LANDING GEAR - LANDING GEAR WARNING HORN REPLACEMENT

The original landing gear warning horn is no longer available. If the landing gear warning horn needs to be replaced, a new landing gear warning horn is available and will require an additional bracket for installation.

MEB-32-01
Page 1 of 25

Figure 8. 310Q Configuration 3 (Sheet 1)

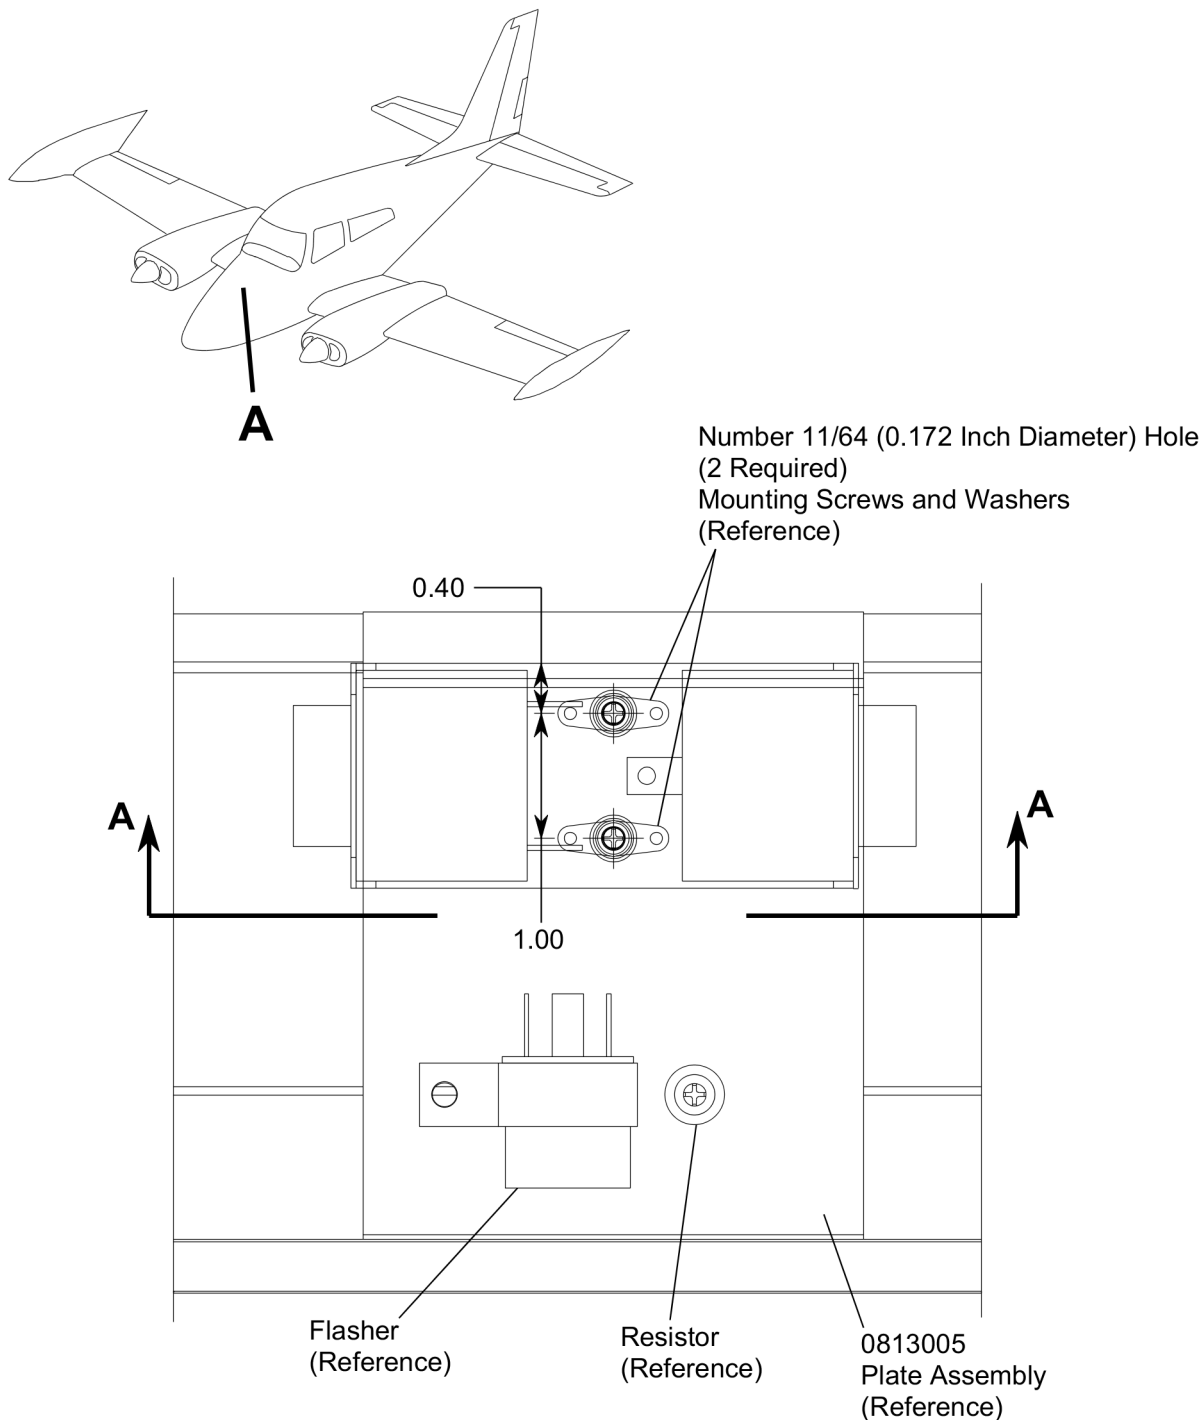
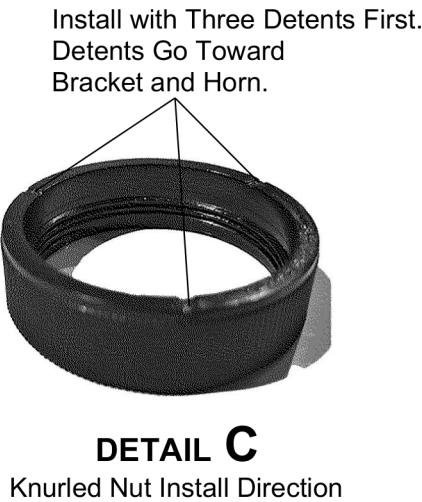
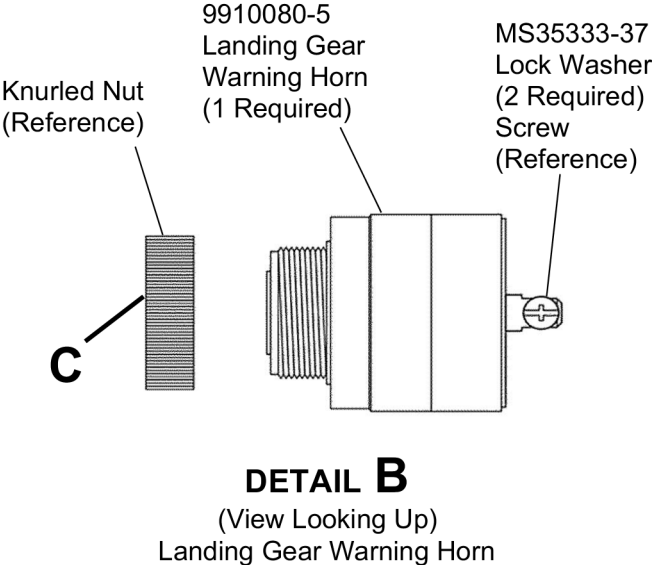
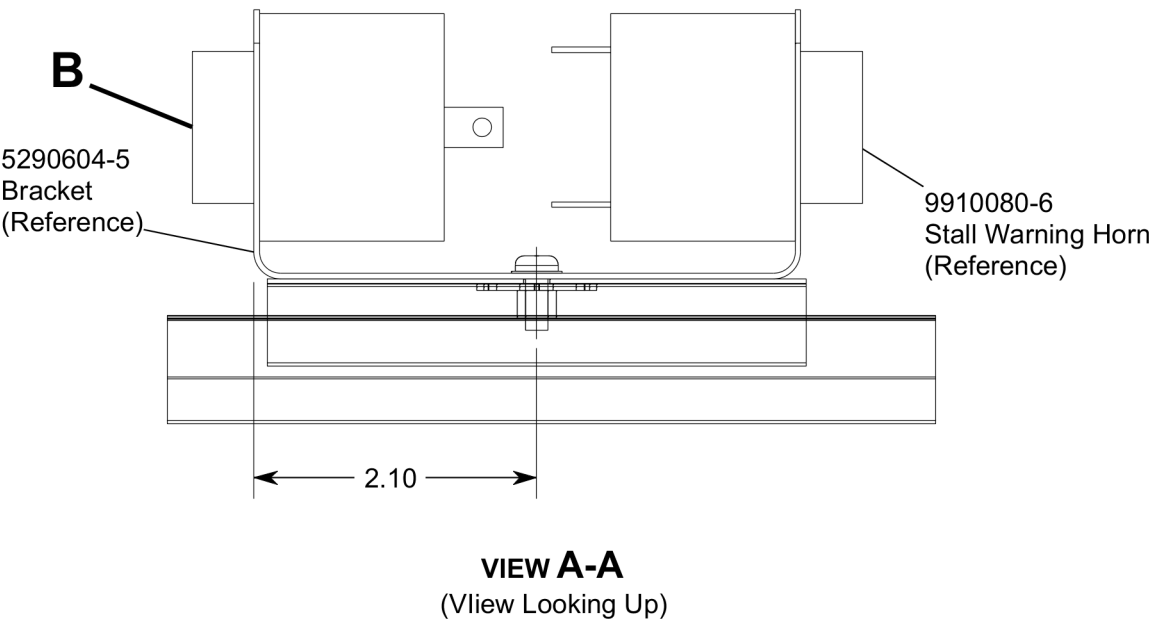
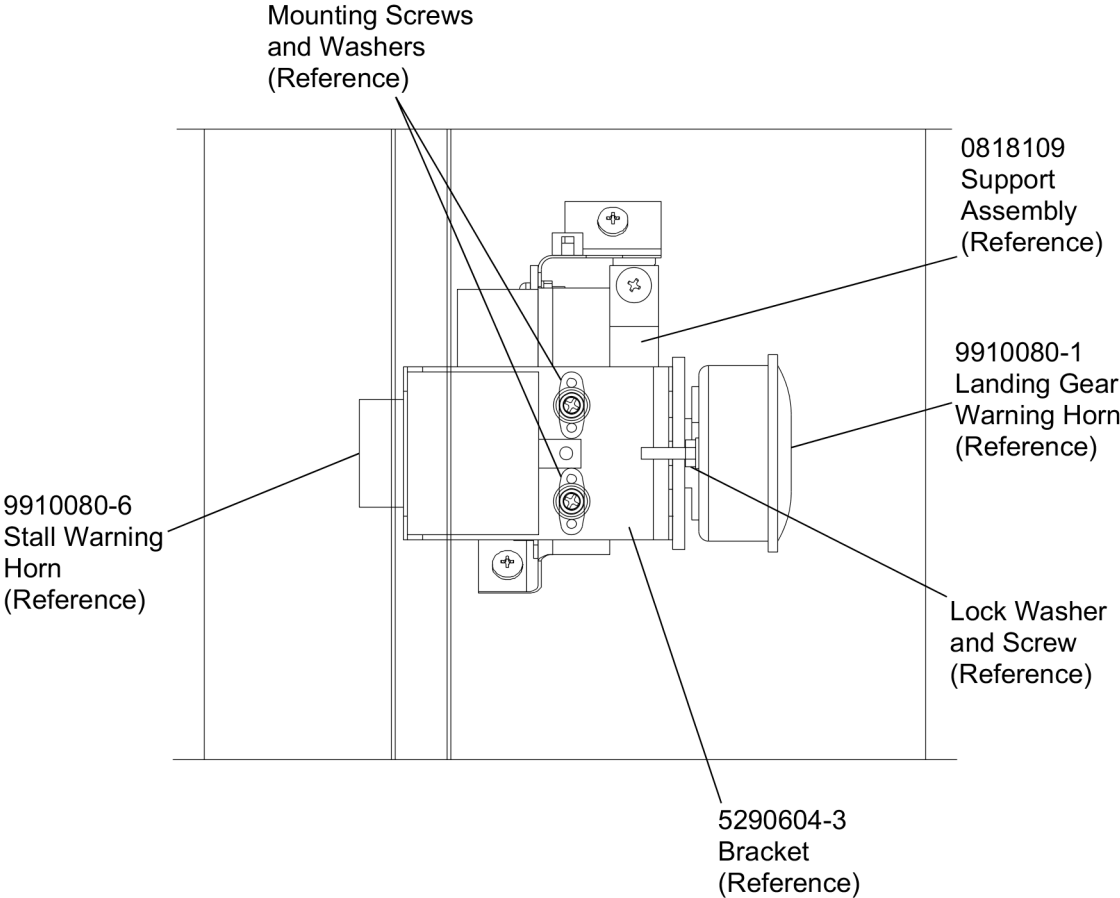
15. (For Model 310Q Refer to Figure 8, Sheet 1 and 2, and for Model 310R Figure 10, Sheet 1 and 2.) Install the 9910080-5 Landing Gear Warning Horn as follows:

- A. (For Model 310Q airplanes.) Match drill the two Number 11/64 (0.172 inch diameter) holes of the 0813005 Plate Assembly to the 5290604-5 Bracket.

- (1) Debur the drilled holes from the 5290604-5 Bracket.
- (2) Apply Color Chemical Film Treatment to all bare metal.
- (3) Go to Step 15C.

- C. Install the 5290604-5 Bracket with the kept mounting screws and washers into the 0813005 Plate Assembly or the 0818109 Support Assembly.

- D. Install the 9910080-5 Landing Gear Warning Horn into the 5290604-5 Bracket.

- E. Install the knurled nut onto the 9910080-5 Landing Gear Warning Horn.

NOTE: The plastic knurled nut must be installed with the three indents toward the bracket and horn assembly. On the internal circumference, the smooth side without threads is installed first, towards the bracket and horn. This technique of installation will make sure the nut fully seats against the bracket and not bottom-out on the threads. If not installed correctly the knurled nut will bottom-out on the threads and the horn assembly will not be fully tightened in the bracket.

Figure 9. 310R Before Configuration 3 Modification (Sheet 1)

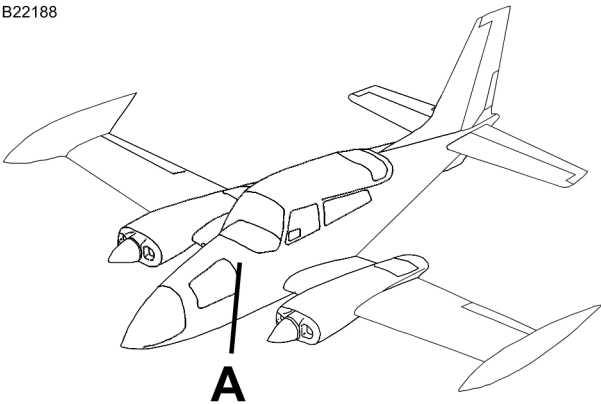
- 14. (For Model 310Q Refer to Figure 7, Sheet 1, and for Model 310R Figure 9, Sheet 1.) Remove the 9910080-1 Landing Gear Warning Horn as follows:
 - A. Remove and discard the screw and lock washer from the 9910080-1 Landing Gear Warning Horn.

- B. Disconnect and label the electrical wiring from the 9910080-1 Landing Gear Warning Horn.
- C. Discard all electrical hardware from the 9910080-1 Landing Gear Warning Horn.
- D. Discard the 9910080-1 Landing Gear Warning Horn.
- E. Remove and keep the 9910080-6 Stall Warning Horn.

- F. Remove and keep the two mounting screws and the two washers from the 5290604-3 Bracket.
